Presentation supporting Comment #87

Submitted by Tom Palkert with comment on December 20, 2015

• Fig. 122-3: TEC conformance

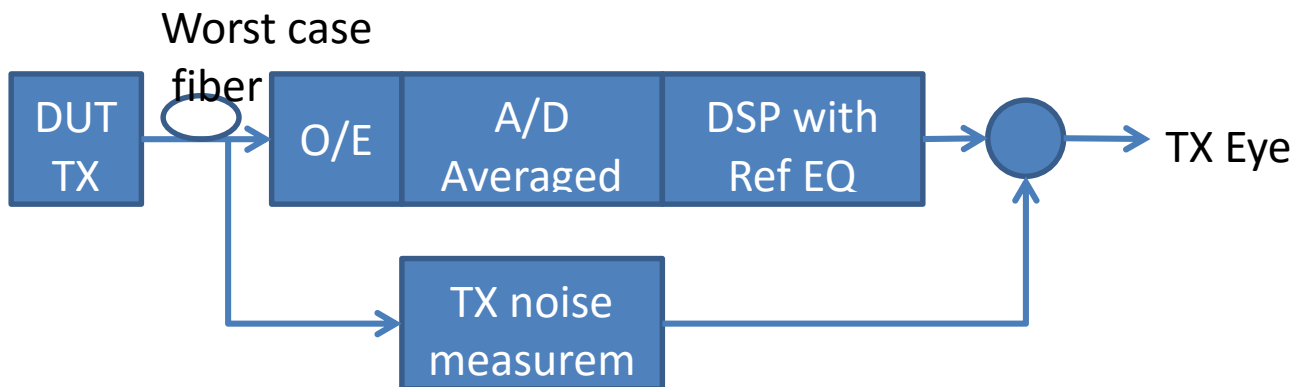
A block diagram for the TEC conformance test is shown in Figure 122–3. Other measurement implementations may be used with suitable calibration.

Each optical lane is tested individually with all other lanes in operation. The optical splitter and variable reflector are adjusted so that each transmitter is tested with an optical return loss of 26 dB. The combination of the O/E and the oscilloscope used to measure the optical waveform has a fourth-order

Bessel-Thomson filter response with a bandwidth of 40 GHz. Compensation may be made for any deviation from an ideal fourth-order Bessel-Thomson response. The clock recovery unit (CRU) has a corner frequency of 10 MHz and a slope of 20 dB/decade. Eye opening is optimized using 5 tap T/2 spaced FFE.
